SUBJECT: CERTIFICATE OF COMPLIANCE NO. 9297 FOR THE MODEL NO. TRAVELLER PACKAGE: Submission of Revision 6 to the Safety Analysis Report (SAR)

Enclosure 1 - Description and Justification of Proposed Changes

The following changes were made to package drawings in Appendix 1.4:

10004E58, Rev. 3, "Safety Related Items Traveller XL & STD"

Figure 1: Bottom Spacer for CE Assembly (left) and Top Restraint System (right) for Non-Westinghouse Fuel (CE and ATOM)

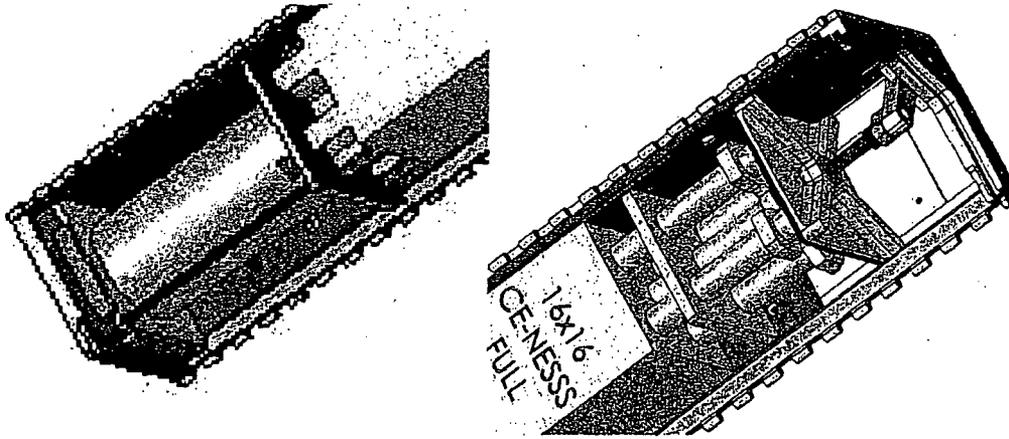
The Traveller will transport three CE fuel assembly designs, all of which are significantly shorter than the Westinghouse fuel assemblies. Therefore a bottom spacer, shown in Figure 1, will support the fuel. This bottom spacer is composed of six major pieces: bottom rubber pad, two stainless steel base plates, stainless steel support pipe, top pad, and rod handle. Data for the bottom spacer components are given in Table 3. Total weight for the bottom restraint system is 34.5 lb.

The CE fuel will use a variant top restraint system, also shown in Figure 1. The major components of the restraint system include: an axial clamp arm, clamp arm extension, threaded rod, clamp arm extension, axial base plate, and bottom pad. Data for the bottom spacer components are given in Table 4. The total weight for the top restraint system is 7.5 lb.

For a bottom nozzle end drop performed with the CE fuel design, the 6" schedule 40 pipe in the bottom spacer assembly is the only component that might be likely to buckle. The longest version that will be used is 13.25" long. The longer pipe is used since it is more prone to buckling, but the heaviest CE fuel assembly is used to bound the fuel types by weight. This combination is the most conservative combination of fuel types and support pipes. The pipe has an OD of 6.625", an ID of 6.065" and a cross-section area of 5.58 in². Using the Rankin formula for short columns with both ends fixed:

This is equivalent to the load of a 1500 lb FA decelerating at 130 g. Some buckling of the fuel spacer assembly may occur but load will be transferred from the impact pillow in the outerpack through the clamshell bottom head to the fuel assembly. The fuel assembly is never in free-fall and will not impact the clamshell bottom head with a significant differential velocity.

The top restraint system to be used with non-Westinghouse fuel uses a 0.75" threaded rod. Four different rod lengths are used, with the longest having a total length of 5.875". Ignoring the length of the rod supported by the axial clamp arm and the axial base plate the maximum load before buckling is:

$$P = 30,000 \times 0.442 / [1 + 0.00064 \times (5.875^2 / 0.375^2)] = 11,500 \text{ lbs}$$

The CE top restraint system is substantially stronger than the top restraint system used in the CTU test. This would allow more force from the outerpack impact pillow through the top restraint system to the fuel assembly and should prevent rebound of the clamshell during the top end drop.

Figure 2: Top Restraint System For Westinghouse Fuel Assemblies

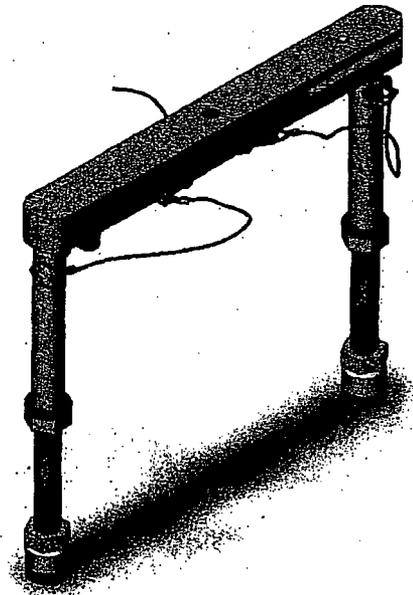
The top restraint system in the CTU drop test incorporates a clamp arm with two tubes at each end, as shown in Figure 2. The tubes are 0.75" outside diameter and are drilled and tapped to accept a 0.625-11 threaded rod. The tube is 4.5" long. The threaded rod (not including the support pads) is 6.075". Total length below the clamp arm is 9.56" including the 0.92" foot. While shipping a 17x17 XL fuel assembly, approximately 1.94" of the .625-11 rods are threaded into the 0.75" tube.

The cross section areas of the threaded rod and the tube are approximately 0.307 in² and 0.135 in² respectively. The total column length is approximately 8.64 in. The resulting slenderness ratio (based on the tube diameter) is

The general definition of a short column is one where the L/r is less than 100. This is clearly the case for the two legs of the 17x17 top restraint system. The allowable yield strength of ASTM A240 type 304 stainless steel is equal to or greater than 30,000 psi. Rankine's formula for short columns is for columns with L/r between 20 and 120, can be used to provide a simple comparison between top restraint systems. For the 17x17 top restraint system used in the CTU test:

P is calculated to be 3100 lbs. Because two clamp arms are used, total load before buckling is 6200 lbs.
